| PROJECT: Fusor Device | | | | |
| TITLE: Machined Flange | | | | |

DETAIL B
SCALE 4:1

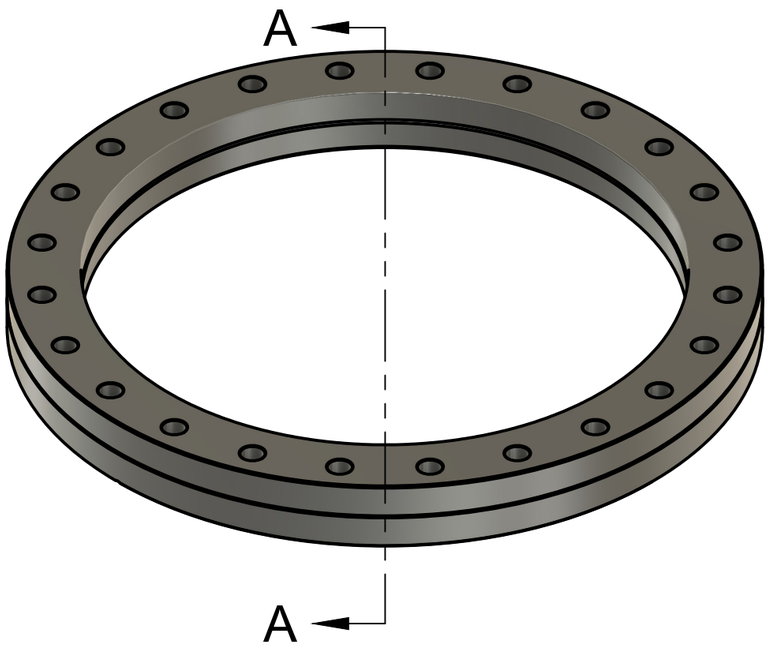
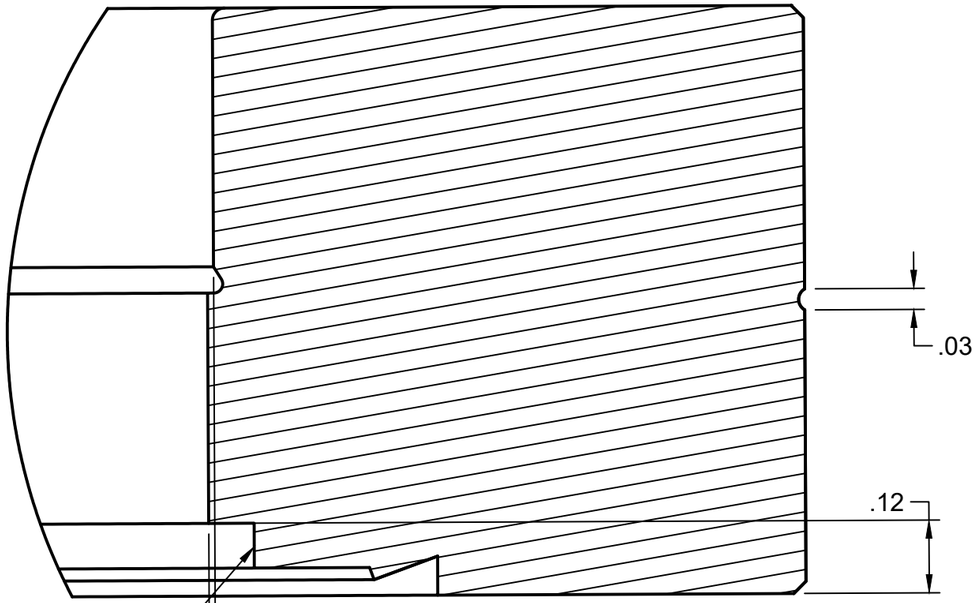
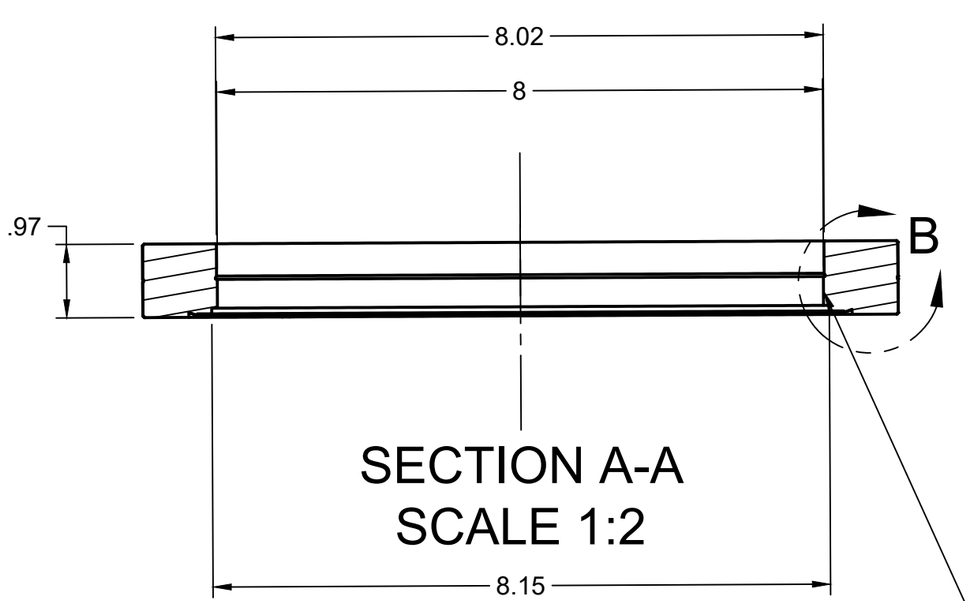
1. INCREASE INNER DIAMETER OF BOTTOM LIP FROM Ø7.89 TO Ø8.00 TO MAINTAIN CONTACT WITH STEEL HEMISPHERE.

2. GROOVE DIMENSIONS OF 8.15 × 0.12 ARE ACCEPTABLE FOR ALTERATION. (DESIGNED AS RELIEF GROOVE FOR WELD AT BOTTOM OF HEMISPERE)
